APPLICANT: Omaha Public Power District

FACILITY: Fort Calhoun Station, Unit 1

SUBJECT: SUMMARY OF MEETING WITH OMAHA PUBLIC POWER DISTRICT (OPPD) TO DISCUSS DRAFT RESPONSES TO REQUESTS FOR ADDITIONAL INFORMATION (RAIs) FOR THE RENEWAL OF THE OPERATING LICENSE FOR FORT CALHOUN STATION, UNIT 1 (FCS)

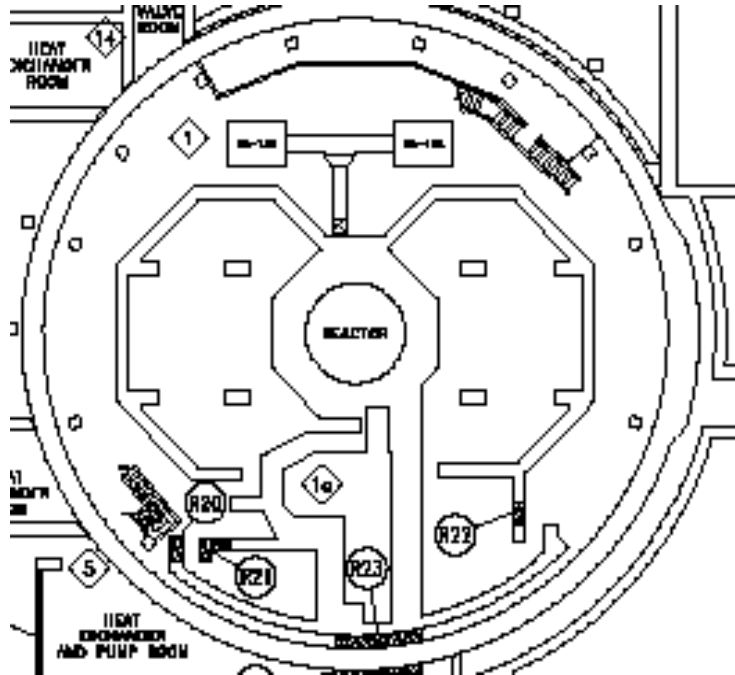
3.5.3-D1 Based on the information in LRA Table 3.5-3, row number 3.5.3.04, and in FCS AMP B.2.10, the applicant plans to inspect and review the masonry walls in accordance with enhanced GALL program XI.S5, "Masonry Wall Program." As the ungrouted masonry walls in containments are subjected to higher sustained temperatures ($> 110^{\circ}\text{F}$), humidity, and radiation, please provide the following information for the staff to make a reasonable conclusion regarding the adequacy of these walls during the extended period of operation:

1. The masonry walls in containment are identified as R20, R21, R22, and R23 in the following figure of the 989' elevation level of containment.
